Applicant: Eiji Nishibe et al. Attorney's Docket No.: 10417-103001 / F51-139075M/SW

Serial No.: 10/007,384 Filed : October 22, 2001

## REMARKS

FIG.9

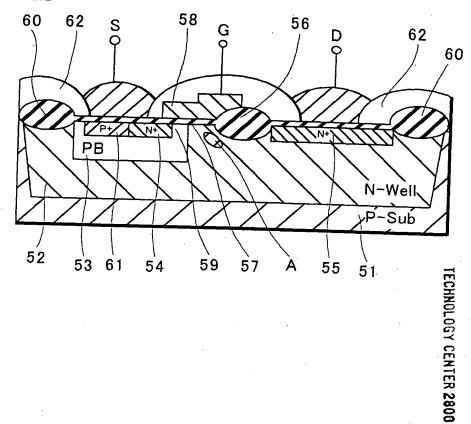
Figure 9 on drawing sheet 5 has been amended to include the legend "Prior Art." A replacement drawing sheet is attached hereto.

PRIOR ART
